7060000 RAISED PAVEMENT MARKERS AND BITUMINOUS ADHESIVE  
COMMENTS FROM INTERNAL/INDUSTRY REVIEW

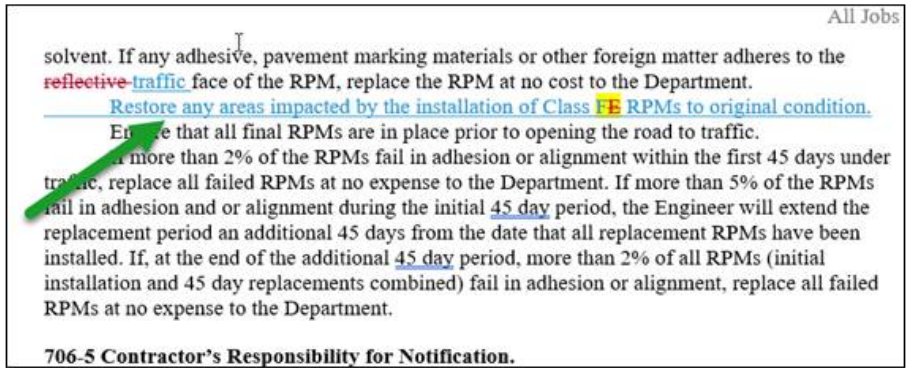
Could we update the spec as follows (or something similar), to cover projects without Final Surface markings? We still have enough push button and non-resurfacing projects using the pay item. Proposed changes in blue highlight

No need to specify class in pay item description; one pay item “group” will cover both types.

Response: (12-3-18) Agreed. Change made.

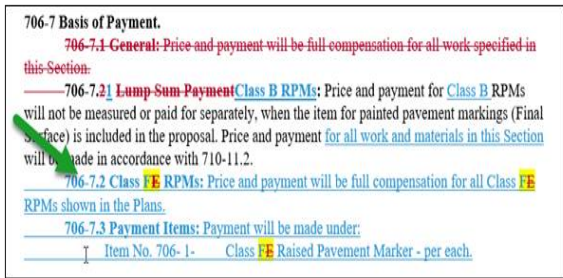
First question concerns the sentence indicated by the green arrow in the first screen shot below. The language seems rather vague and therefore highly questionable regarding its enforceability. No reply required, but I just wanted to ask the question. If Specs Office feels it is enforceable, then I have no further comments.

Should the Class B RPM's have some language regarding "all work and materials"? (See green arrow in screenshot below.) It would appear the Class F language could be misconstrued to mean only the material cost is covered by a 706 pay item. Maybe full compensation covers it, but I just wanted to check that the different language used in each is due to paying for each differently. It very well may be the case, but I just wanted to ask the question regarding the different language. If both, Class B and Class F payment includes all work and materials, then I'd suggest it be stated for both.

Response: (12-3-18) Regarding payment information, agreed. Change made.
